DESIGN REVIEW BOARD
1200 STEWART STREET
 EARLY DESIGN GUIDANCE

NOVEMBER 25, 2008
 DPD PROJECT 3007548

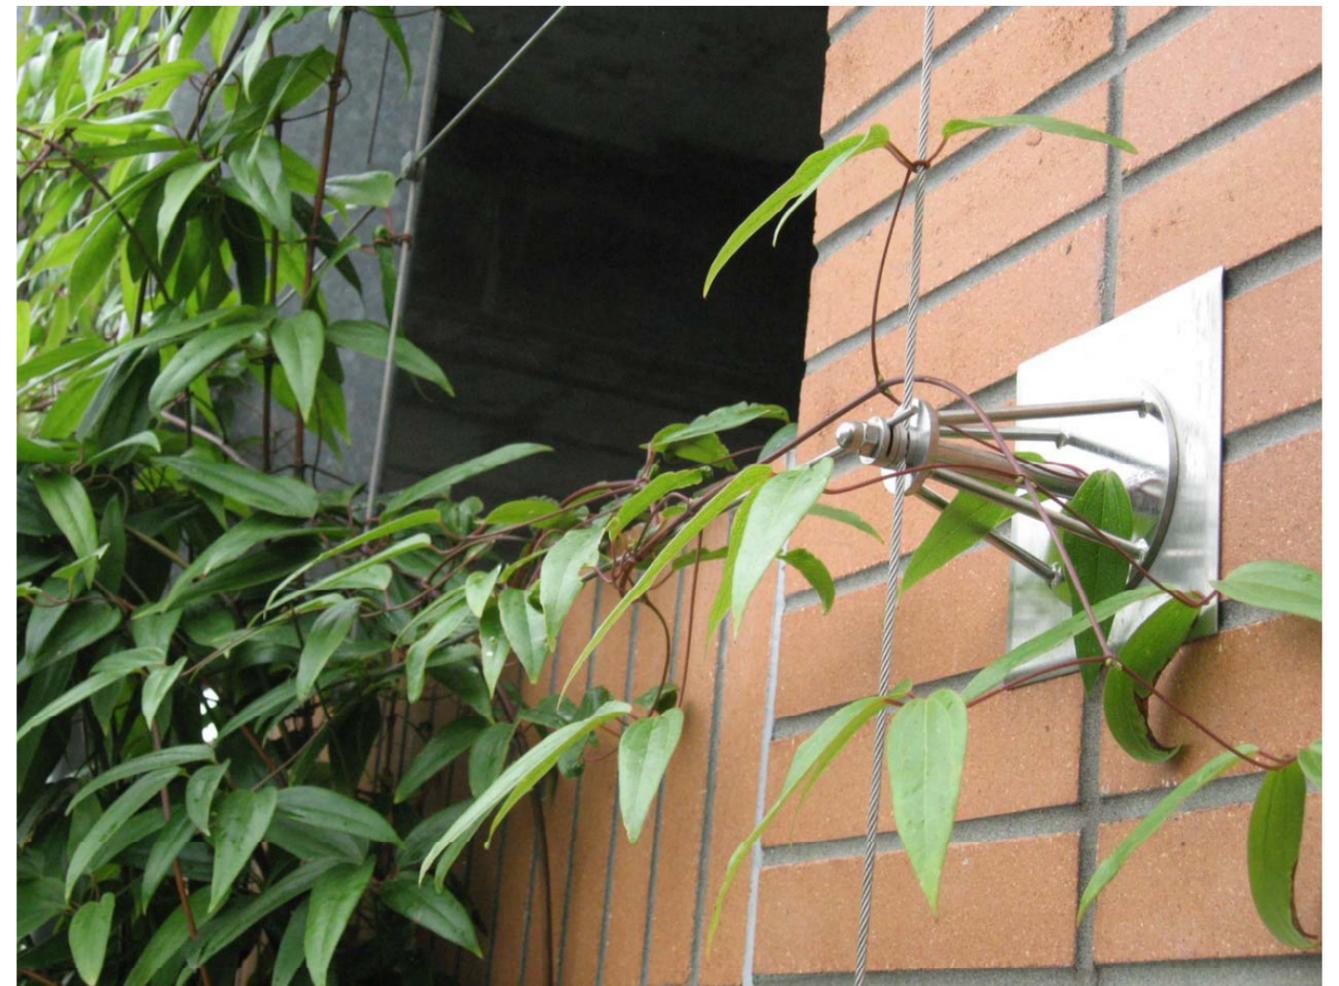
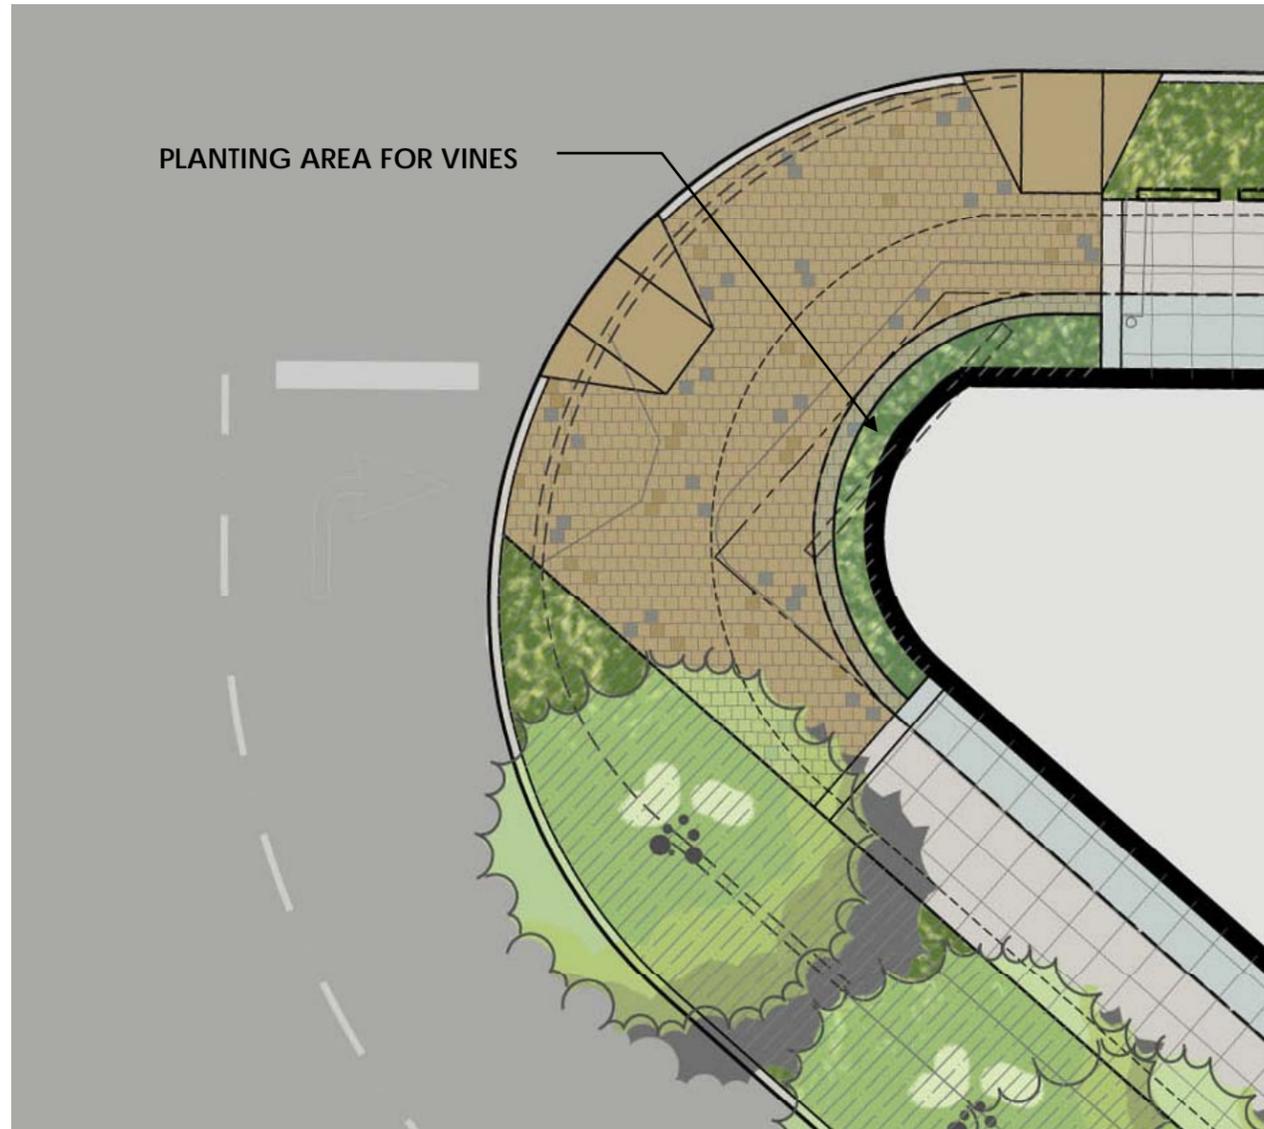
The podium level below the West Tower featured a living green wall. The Board wanted additional information about how the green screen wall would work and how it would be maintained long-term.

Mr. Michaelsen, informed the Board that the system is designed to be easily maintained for the long-term with robust vegetation.

Response: The wall surrounding the service area will have a unique treatment; a stone veneer is proposed, bringing in an interesting color and texture unique to the development. A narrow, irrigated planting area at the base of the wall will accommodate vines and a metal trellis will be attached to the wall for these vines to grow upon. Maintenance will be minimal, requiring only seasonal removal of debris. Plants will be carefully chosen to avoid any interference with the wall veneer.

SECTION
AT STEWART STREET

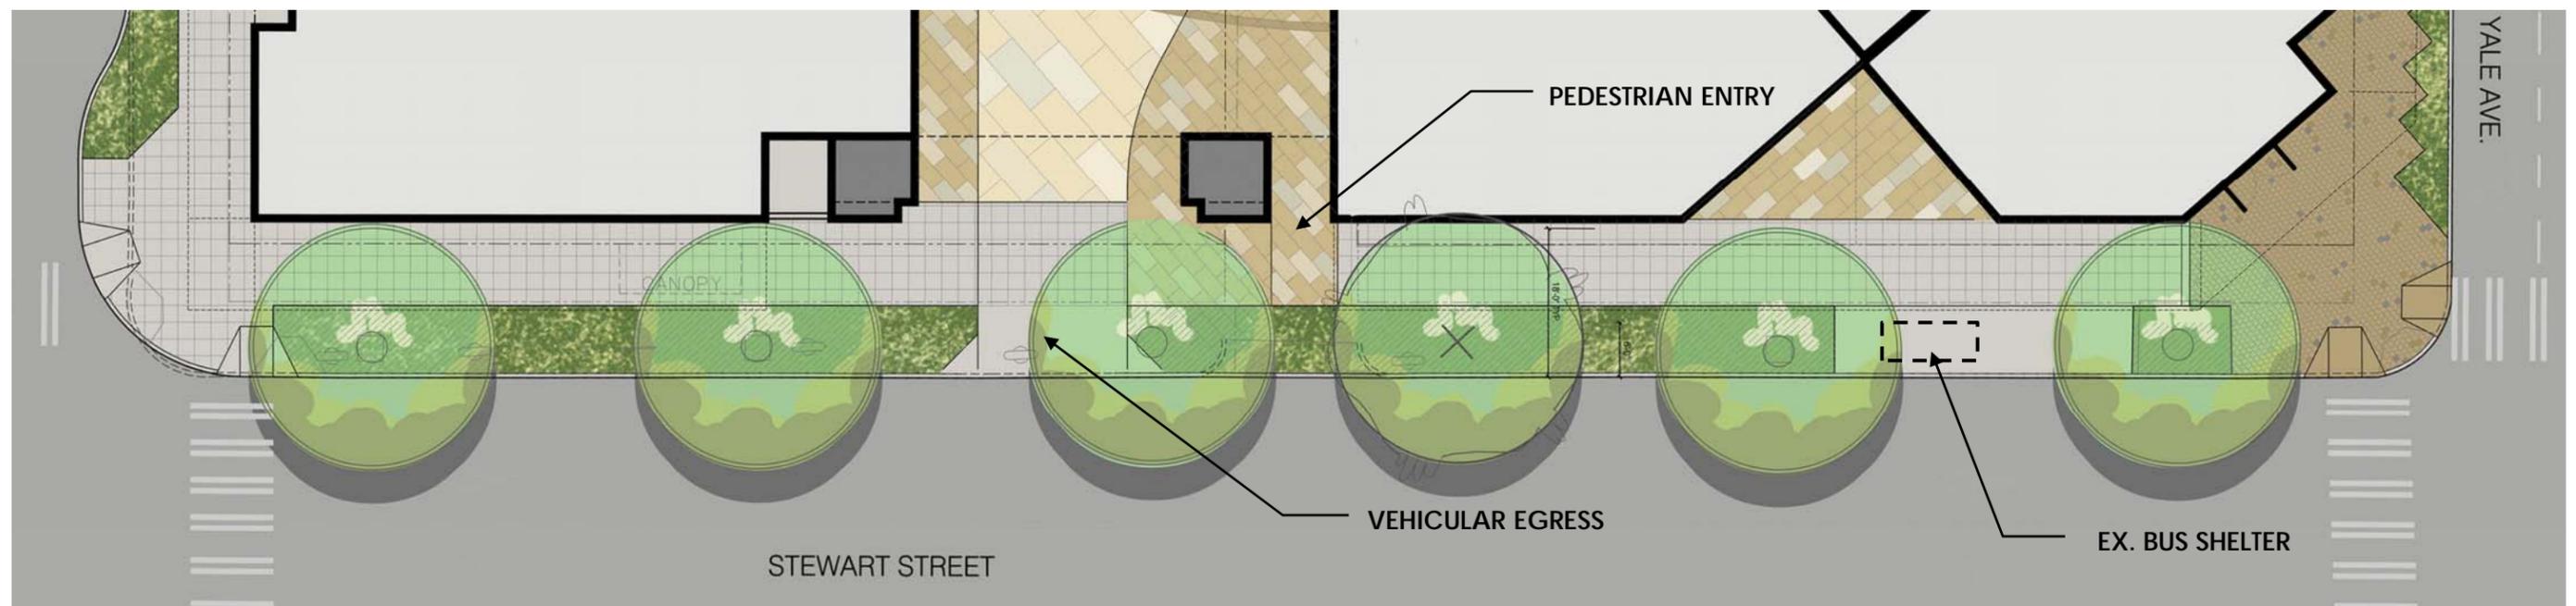
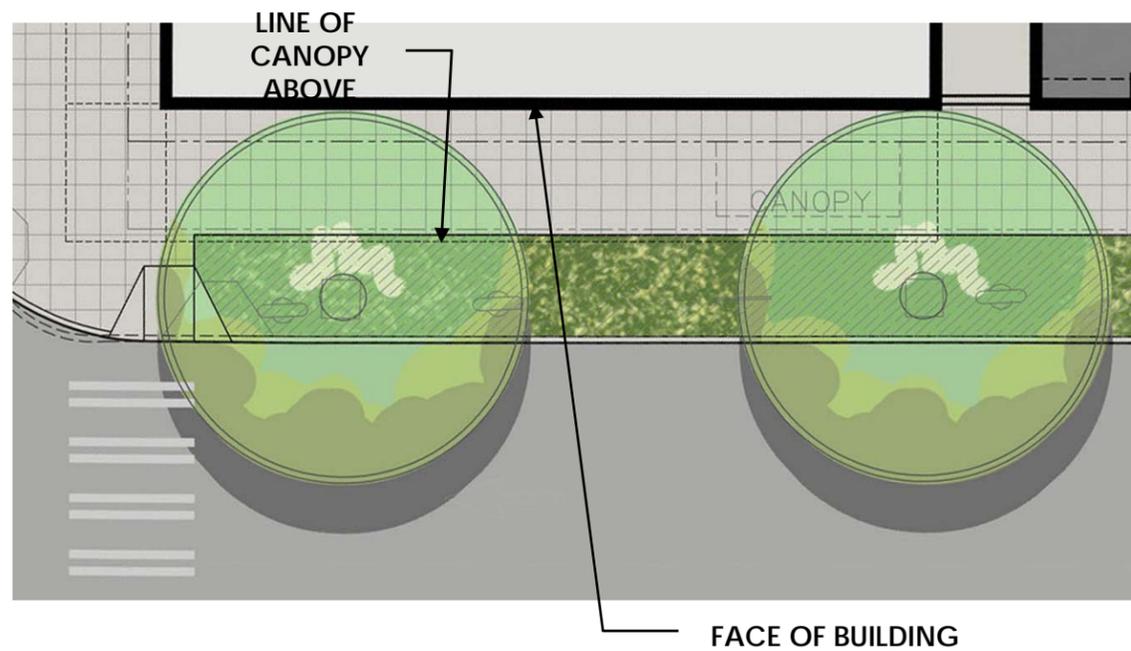
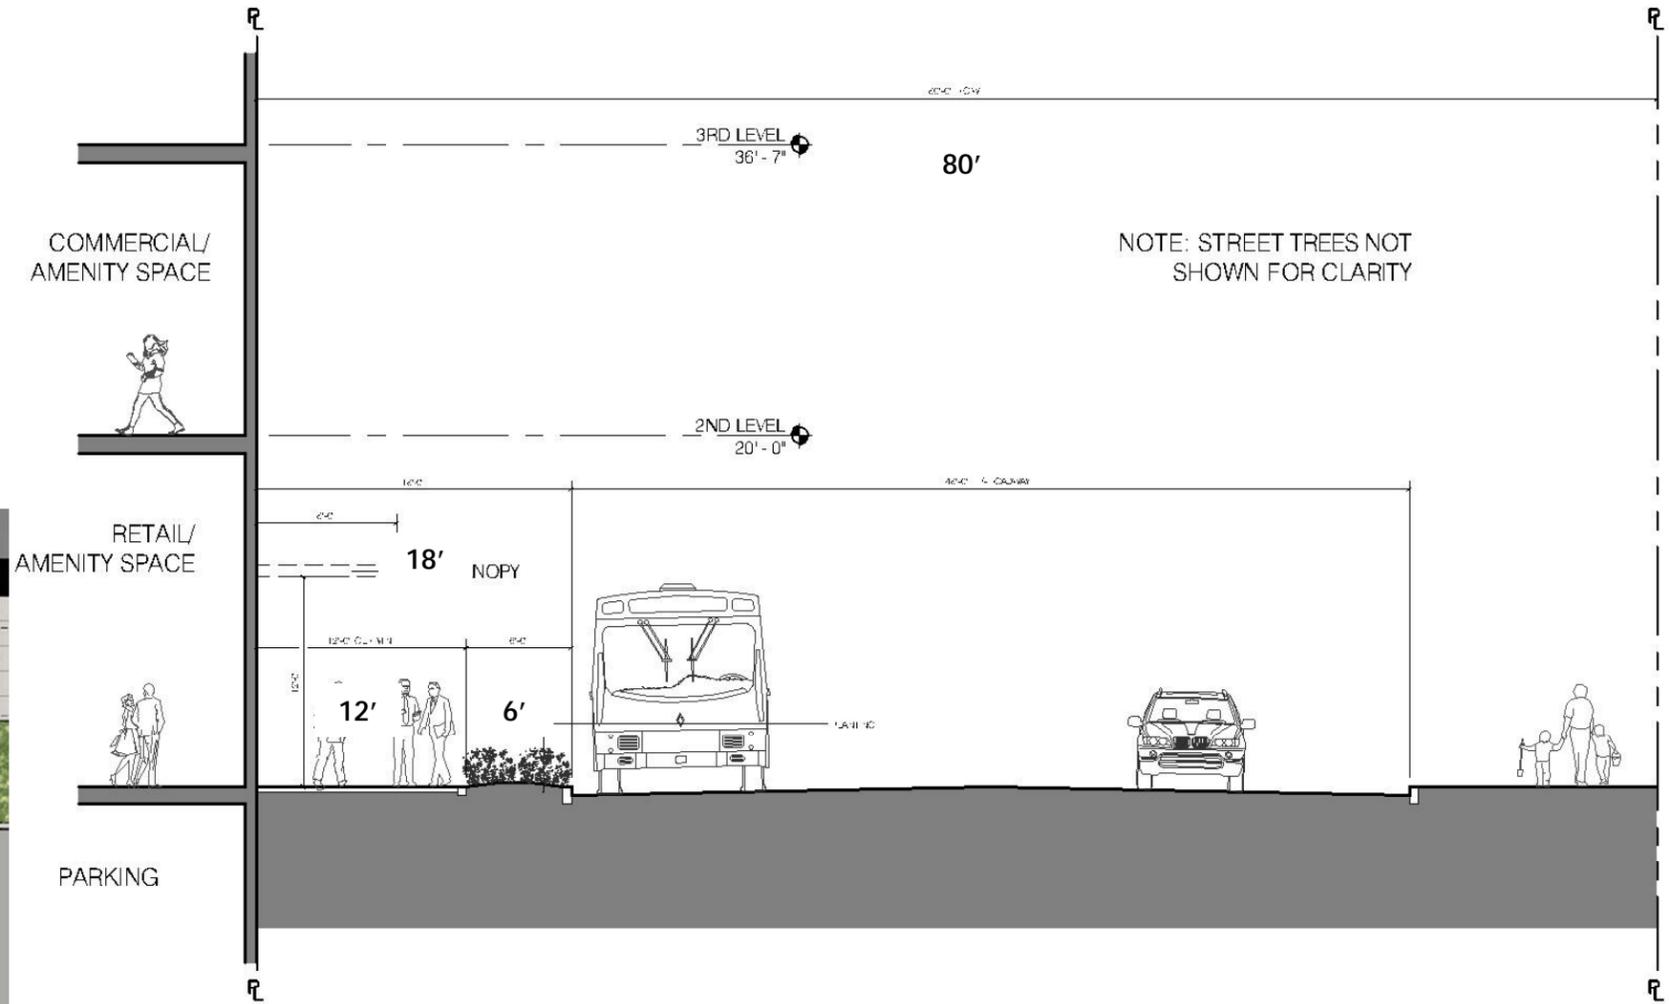
Provide detailed graphics of the pedestrian street experience, with and without landscaping. Include development of entries.

Response: Stewart Street sidewalk to be 18' wide, incorporating a 6' planting strip along the street and a 12' pedestrian path. The existing trees will be retained. The existing bus stop will be retained and enhanced with new furnishings, such as a shelter and/or lean bars. Pedestrian entry through the Internal Arrival Area will be indicated through a change in pavement that leads through the building entry and lobby.

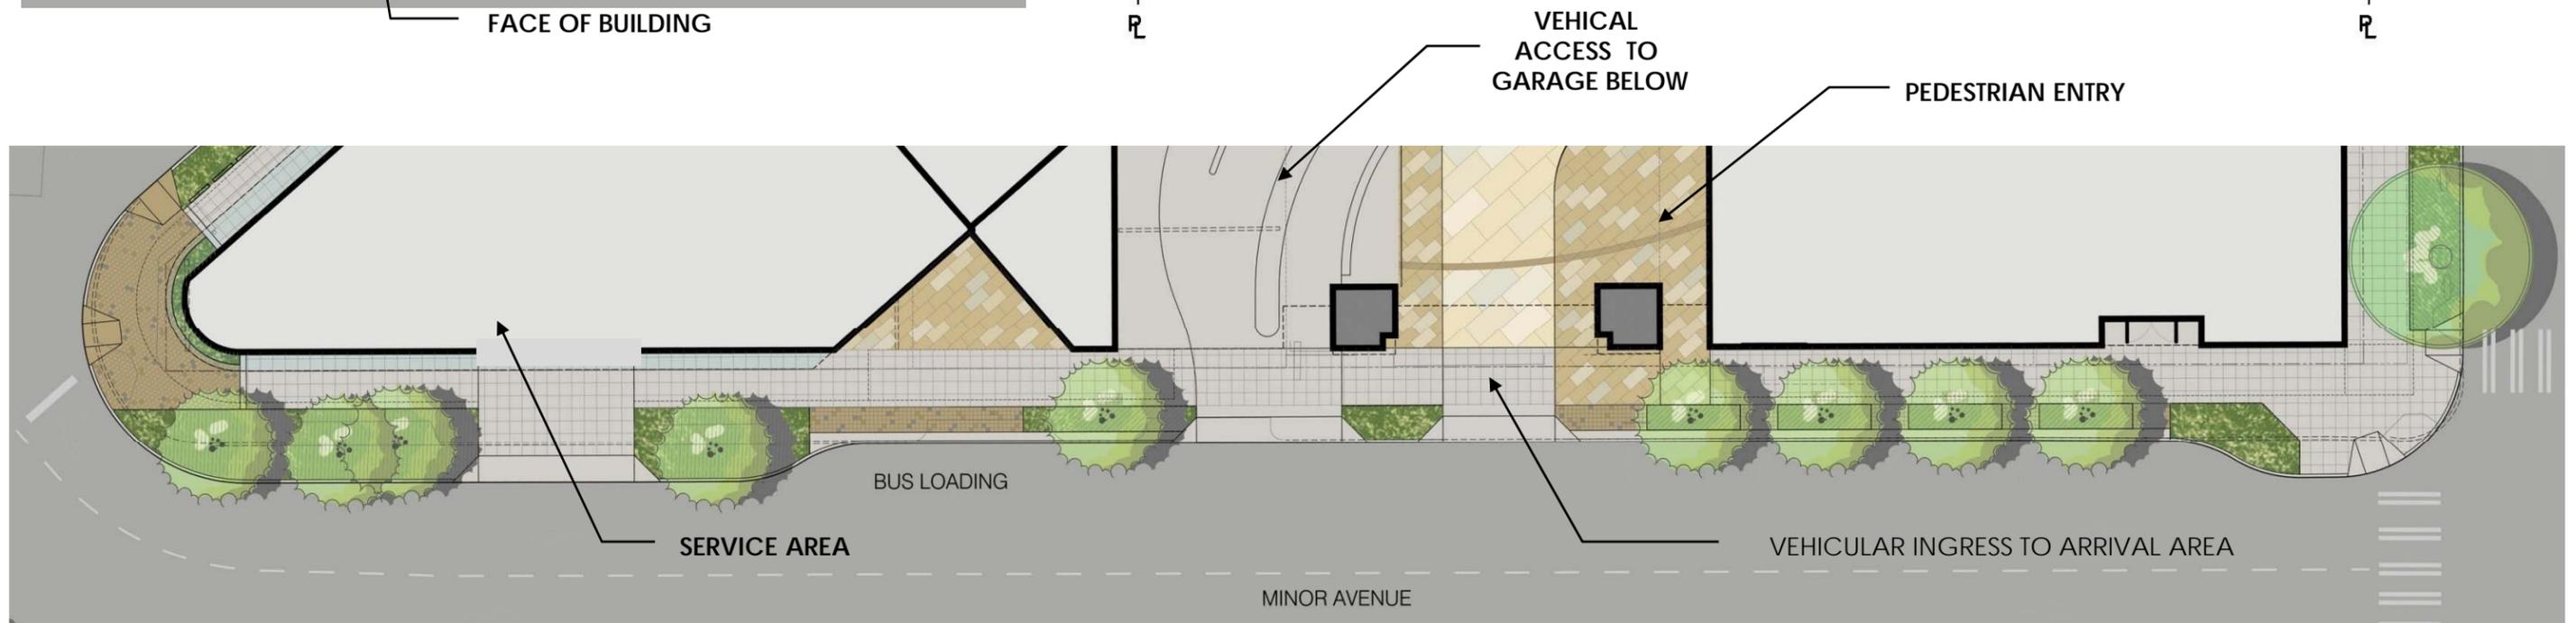
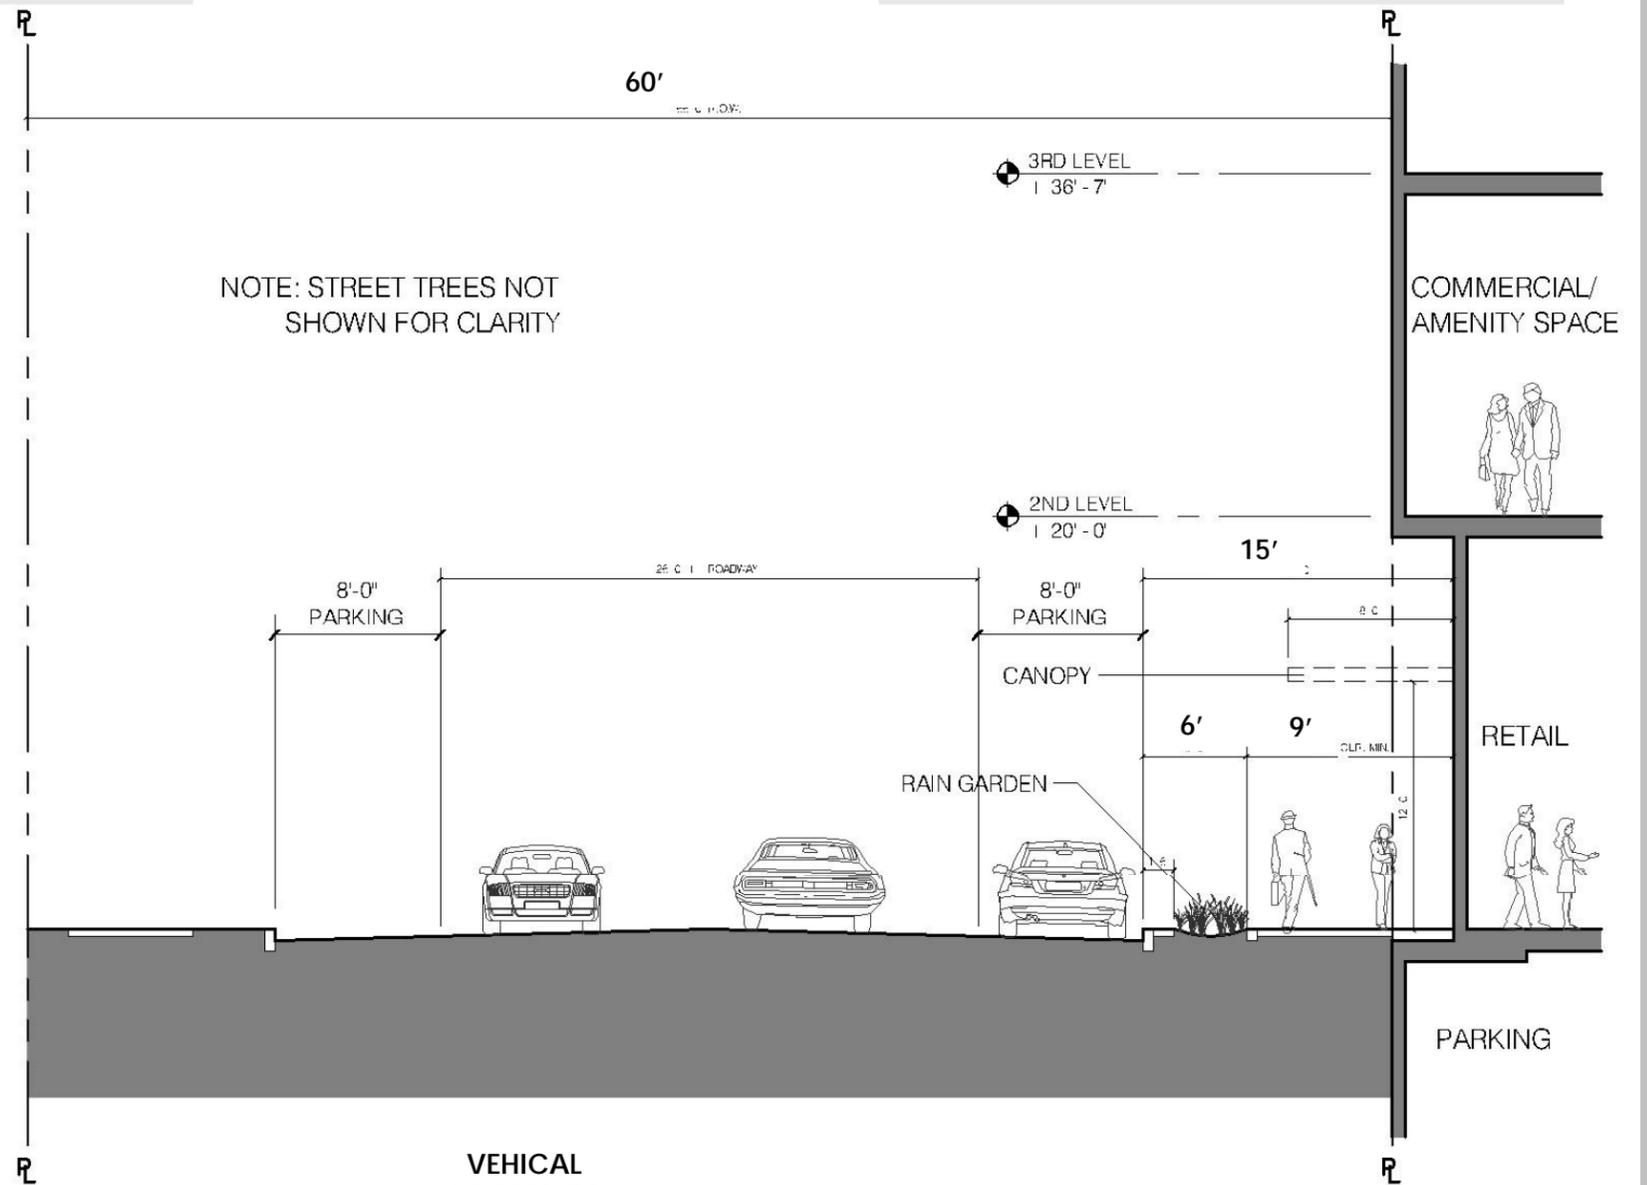
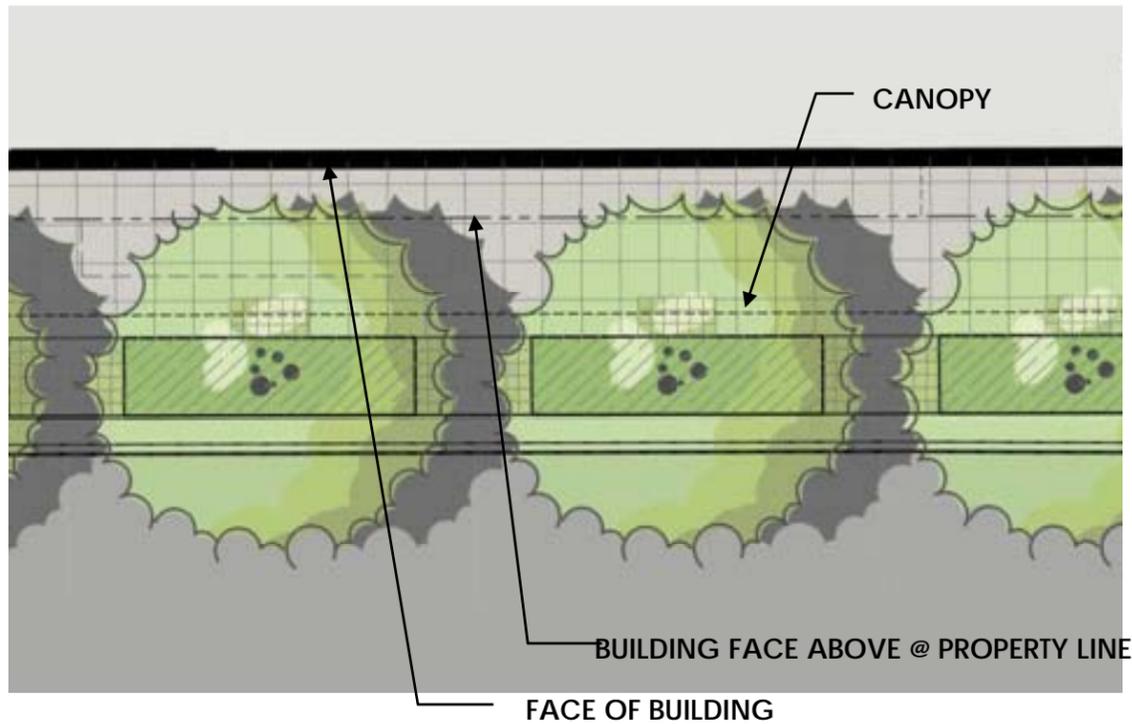
Provide detailed graphics of the pedestrian street experience, with and without landscaping. Include development of entries.

Response: Minor Avenue sidewalk will be widened to 15', incorporating a 6' wide planting strip/vehicle access strip and 9' of pedestrian path. A proposed rain garden strip along the street provides storm water treatment. Street trees and building canopy will provide overhead protection.
